U.S. Department of the Interior
BUREAU OF LAND MANAGEMENT

Well Name: POKER LAKE UNIT 13-24 PC	Well Location: T24S / R29E / SEC 13 / SWNE / 32.218155 / -103.934466	County or Parish/State: EDDY / NM
Well Number: 806H	Type of Well: OIL WELL	Allottee or Tribe Name:
Lease Number: NMNM05912	Unit or CA Name: POKER LAKE UNIT	Unit or CA Number: NMNM71016X
US Well Number:	Operator: XTO PERMIAN OPERATING LLC

Notice of Intent

Type of Action: APD Change

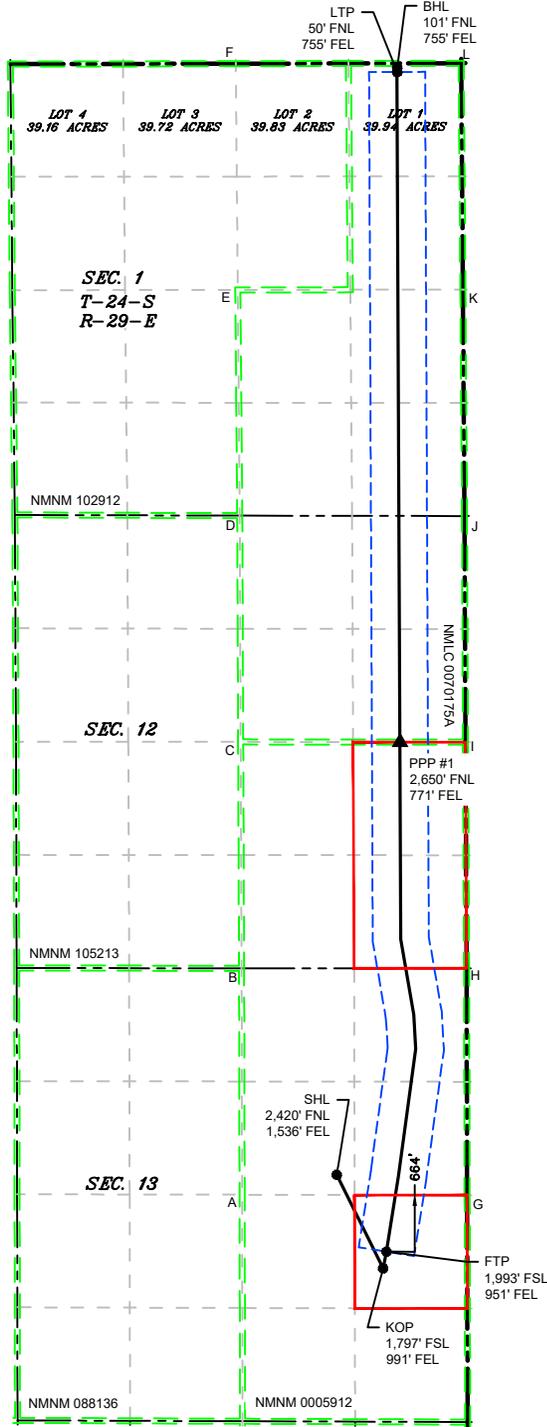
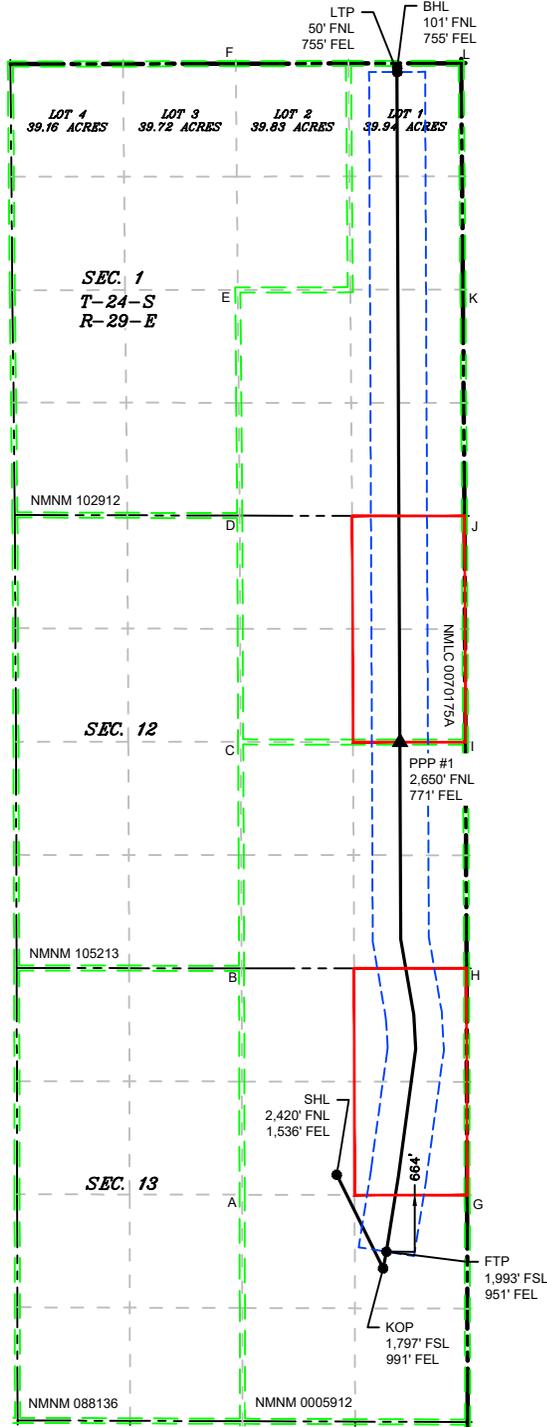
XTO Permian Operating, LLC. respectfully requests approval to make the following changes to the approved APD. Changes to include KOP, FTP, LTP, BHL, proposed total depth, pool, and dedicated acreage.

FROM: TO:

KOP: 2420' FNL & 1536 FEL OF SECTION 13-T24S-R29E 1797' FSL & 991 FEL OF SECTION 13-T24S-R29E

FTP: 1959' FNL & 1329' FEL OF SECTION 13-T24S-R29E 1993' FSL & 951' FEL OF SECTION 13-T24S-R29E

LTP: 100' FNL & 990' FEL OF SECTION 1-T24S-R29E 101' FNL & 755' FEL OF SECTION 1-T24S-R29E

BHL: 50' FNL & 990' FEL OF SECTION 1-T24S-R29E 50' FNL & 755' FEL OF SECTION 1-T24S-R29E

The proposed total depth is changing FROM 22690 MD; 9739 TVD TO 23654 MD; 9730 TVD.

Pool code is changing FROM PIERCE CROSSING; BONE SPRING, EAST(96473) TO CEDAR CANYON; BONE SPRING(11520); PIERCE

Dedicated acreage is changing FROM 719.94 ac TO 439.94 ac
